SERVICE BULLETIN

Outrigger Cylinder Replacement

SB97.1

Machines/Models: TL49

Figure 1

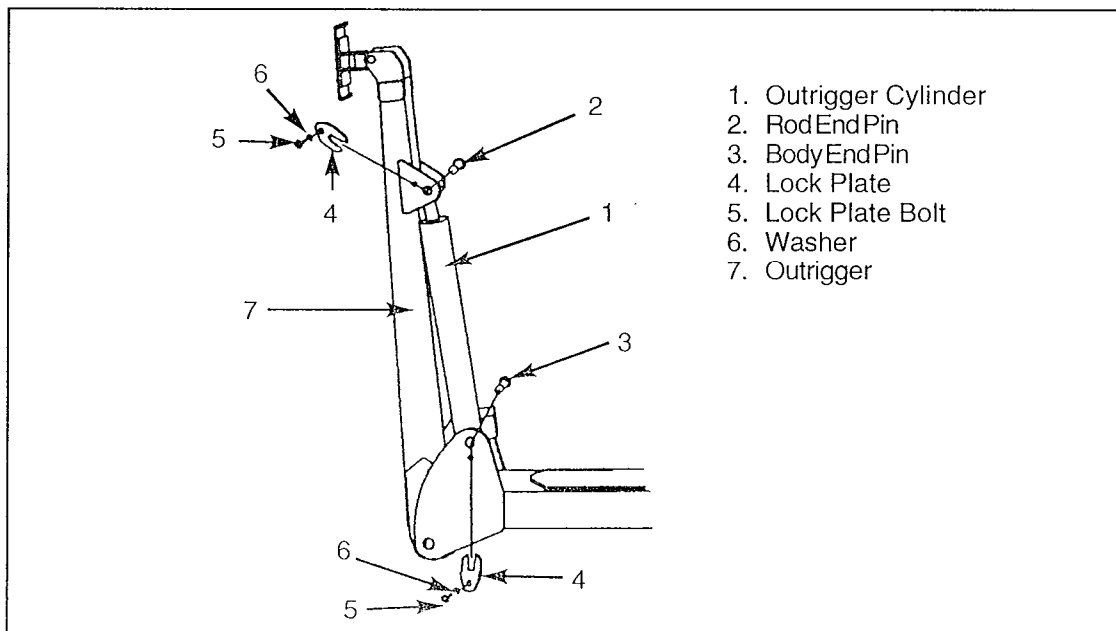
PURPOSE: To replace the present pin lock plates, banjo bolts, dowty washers, and outrigger limit switches with current specifications. Also, the outrigger cylinders are being replaced and will have a more improved performance and better operating characteristics.

2. Disconnect the hoses from the cylinder and plug them to avoid spillage. Tag each hose for reference during reassembly.
3. Remove the securing bolts #5 and washers #6 from the cylinder lock plates. (fig. 1)

4. Remove the lock plates #4 (fig. 1).
5. While supporting the outrigger cylinder, remove the body end pin #3 (fig. 1).
6. While supporting the outrigger cylinder, remove the rod end pin #2 (fig. 1).

7. Remove the cylinder #1 (fig. 1).
8. Remove the outrigger cylinder limit switch cover and disconnect wires. Remove the cable connector and wire from limit switch. Remove limit switch.

4. Install supplied outrigger cylinder #1 on chassis and install rod end pin #2 (fig. 1).
5. Install body end pin #3 (fig. 1).
6. Install supplied lock plates #4 (fig. 1).
7. Apply medium strength thread lock to lock plate securing bolt, install bolt #5 and washer #6 (fig. 1). Torque to 25 ft. lbs.

Figure 2

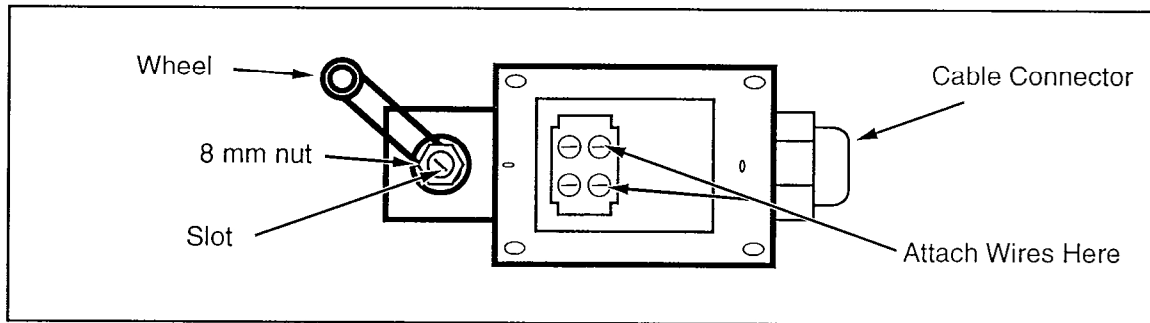
1. Attach the two wire terminals onto the bottom two contacts on the TI-U12-ATT outrigger limit switch, contacts 23 and 24 (fig. 2).
2. Tighten the cable connector.
3. Attach limit switch to quadrant plate.

Figure 3

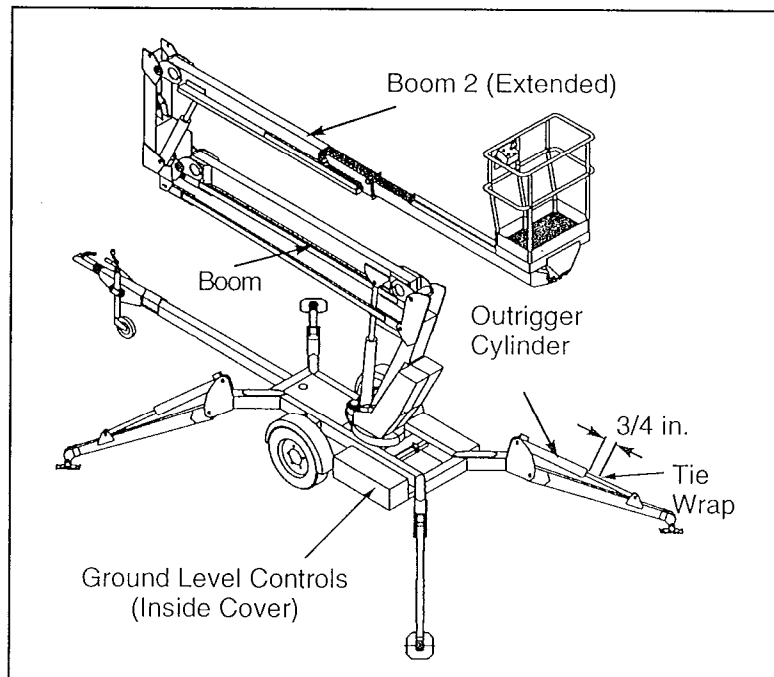
3. Attach a tie wrap around the cylinder rod $\frac{3}{4}$ inch from the cylinder barrel, securing it tightly. Measure the distance accurately on each cylinder.

5. Rotate the turret so that the platform is directly over any outrigger. Allow machine to remain in this position for a minimum of 15 minutes. Measure distance between cylinder barrel and tie wrap installed in step 3. Maximum allowable retraction of the outrigger cylinder is $\frac{3}{16}$ inch. Minimum allowable distance between the tie wrap and cylinder barrel is $\frac{9}{16}$ inch. If outrigger cylinder retraction exceeds $\frac{3}{16}$ inch, the cylinder should be bled per the attached "Bleeding Procedure for TL-49 Outrigger Cylinders and retested. Please consult the upright Product Support Department in Selma if you have difficulty in achieving results outlined above.
